## 4. Revisions to the Draft EIR

In accordance with Section 15132 of the CEQA *Guidelines*, this section presents the changes that were made to the Draft EIR to clarify or amplify its text in response to comments. Such changes are insignificant as the term is used in Section 15088.5(b) of the State CEQA *Guidelines*.

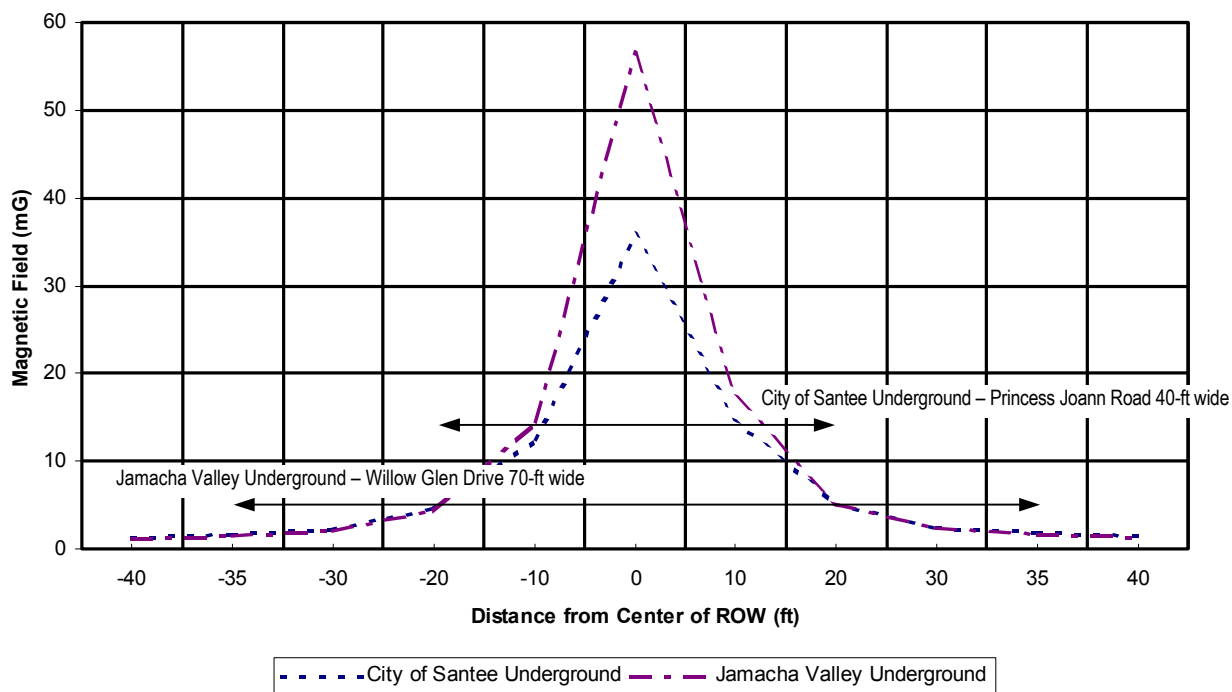
Page D.9-18, under D.9.6.2 Other Field-Related Public Concerns, “Wind, Earthquake, and Fire Hazards” —

Transmission line structures used to support overhead transmission lines must meet the requirements of the California Public Utilities Commission, General Order No. 95, Rules for Overhead Electric Line Construction. This design code and other applicable requirements ~~the National Electrical Safety Code~~ include loading requirements related to wind conditions. Transmission support structures are designed to withstand different combinations of loading conditions including extreme winds. These design requirements include use of safety factors that consider the type of loading as well as the type of material used, e.g., wood, steel or concrete. Failures of transmission line support structures are extremely rare and are typically the result of anomalous loading conditions such as tornadoes or ice-storms.
